STAFF REPORT
WEST ALLIS PLAN COMMISSION
Wednesday, December 11, 2024
6:00 PM

4. Site, Landscaping, and Architectural Design Review for La Finca, a proposed Restaurant (limited), at 7033 W. National Ave. (Tax Key No. 453-0602-000).

1E A100 FIRST FLOOR DEMOLITION PLAN 1/4"=1'-0"

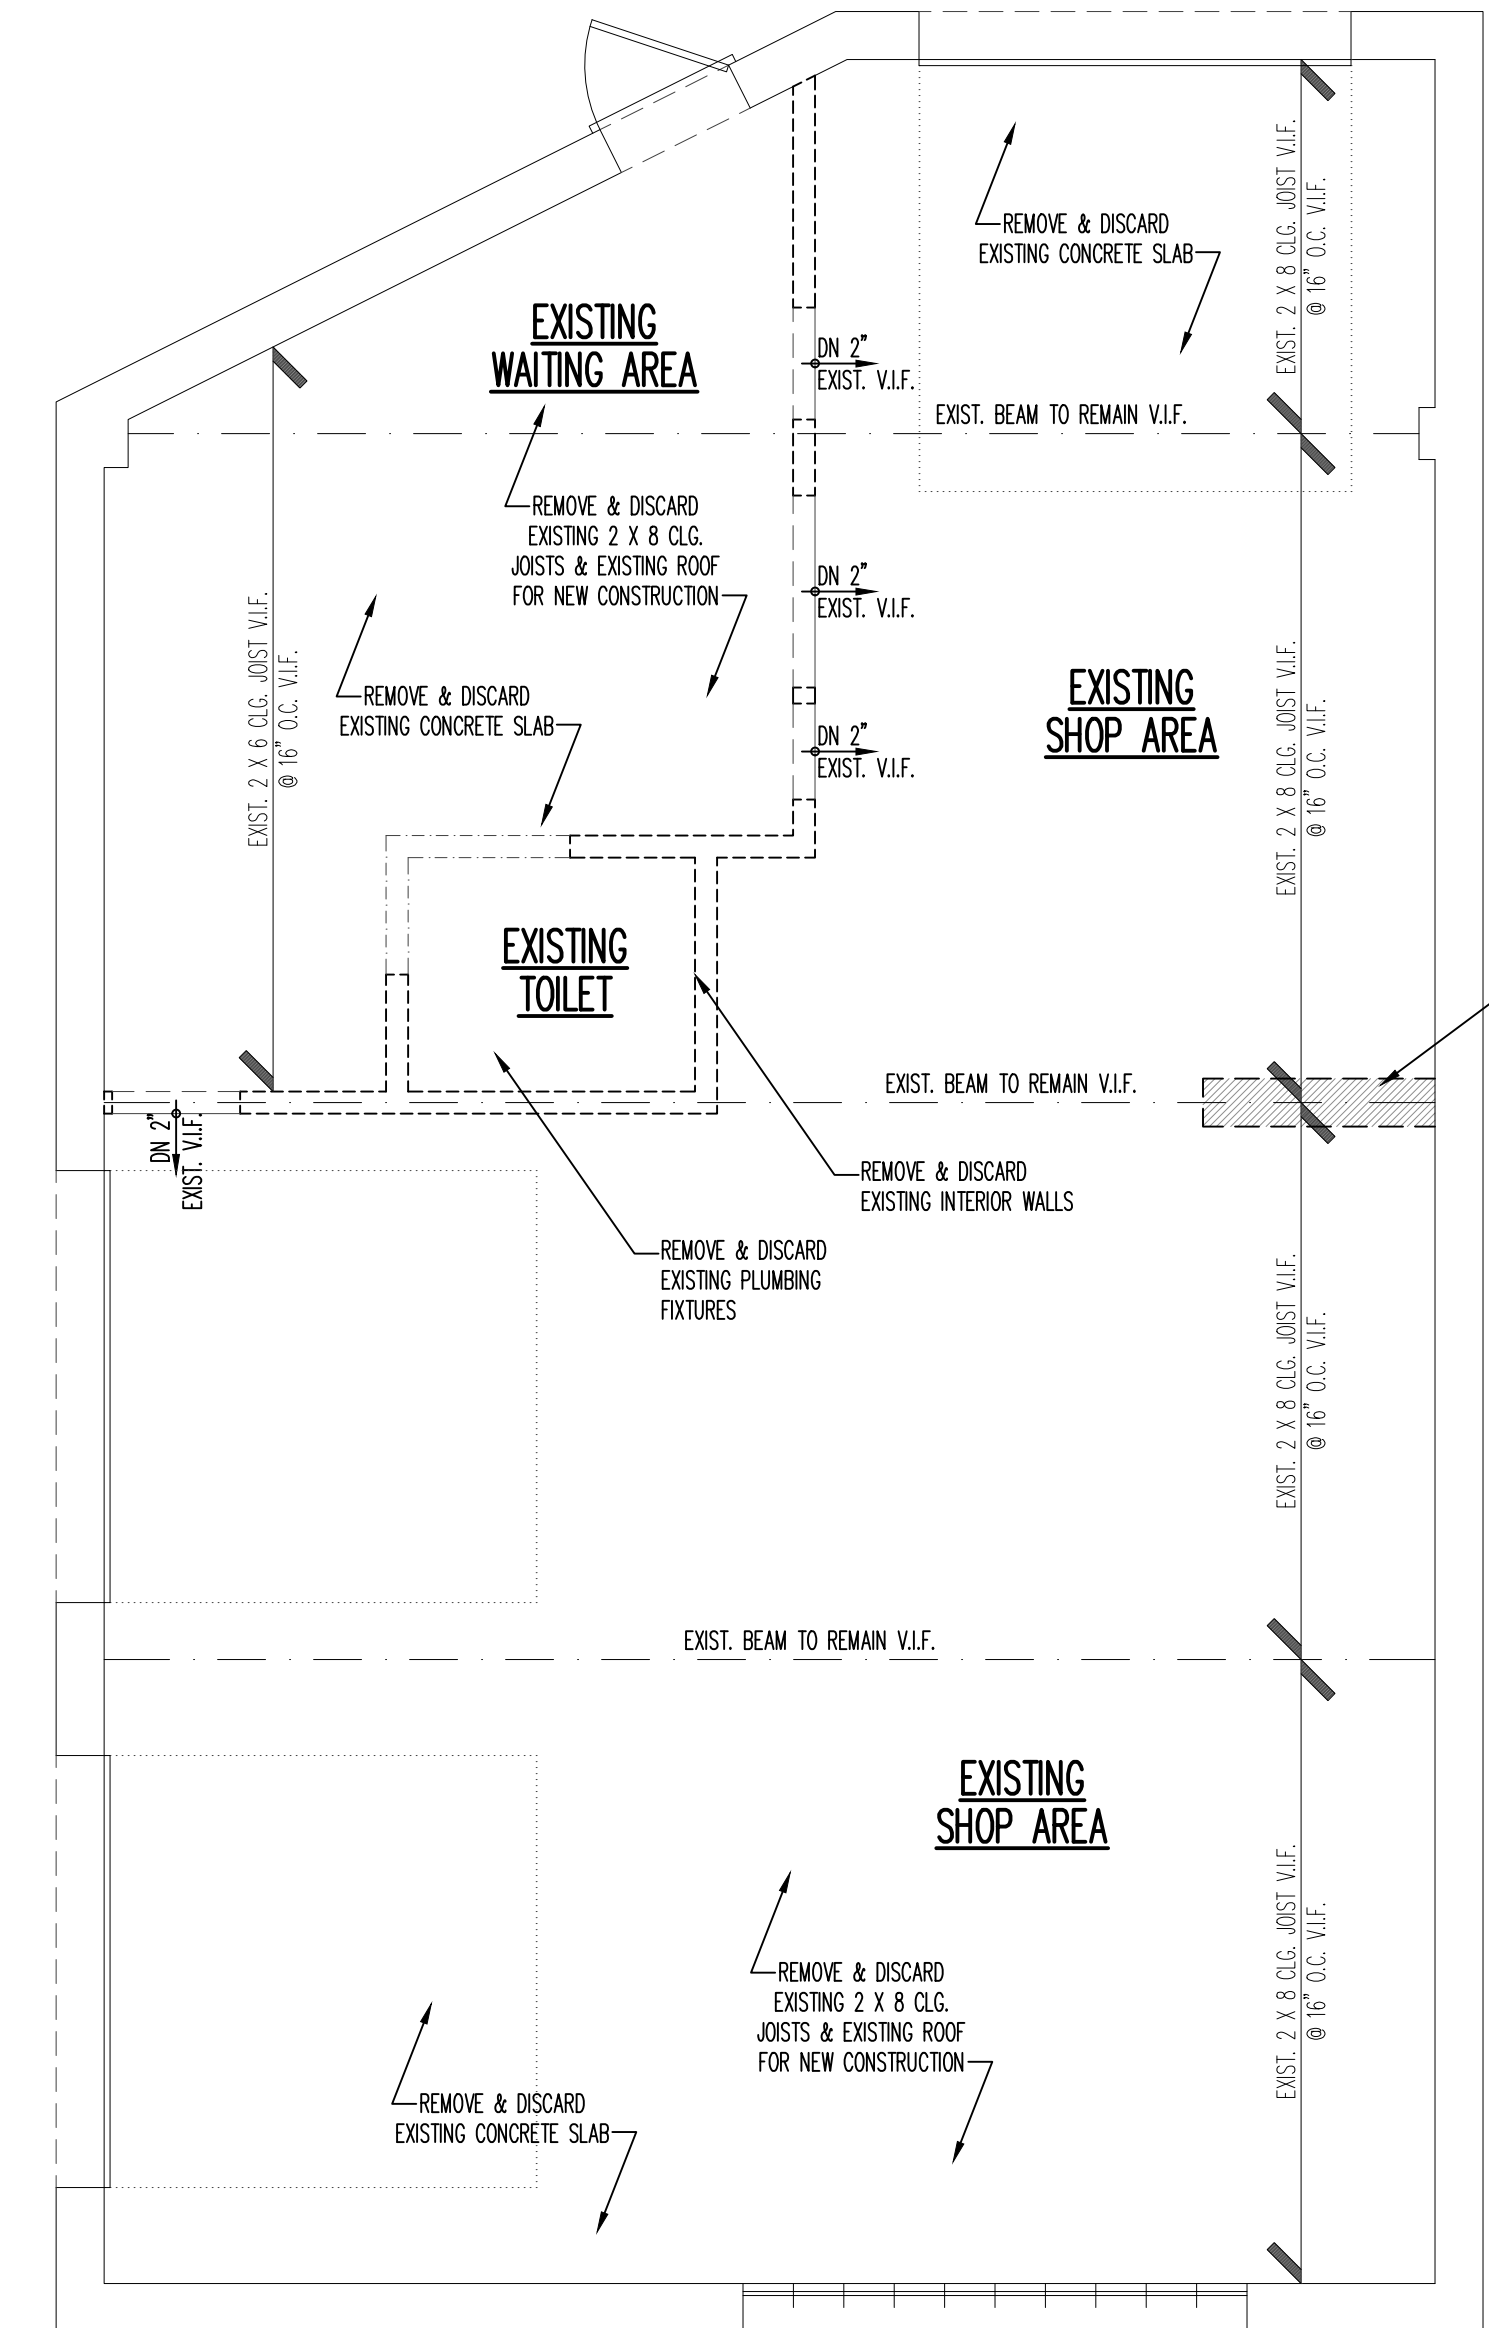
The proposed business shows a revamped floor plan to accommodate for the restaurant use. Customer access to the first floor of the restaurant is provided by entry doors on the north and west sides of the building. Overhead garage doors can also be found providing access to the north and west sides of the building. The floor plan shows an open seating concept making up most of the first floor. Two restrooms are shown along with a prep kitchen, cooler, and dry storage area. Stairs

in the east portion of the building provide access to the second floor. The second floor shows an open seating area with tables and chairs, along with countertop seating. A utility closet is also shown. The indoor area leads directly to the outdoor patio area which includes additional seating.
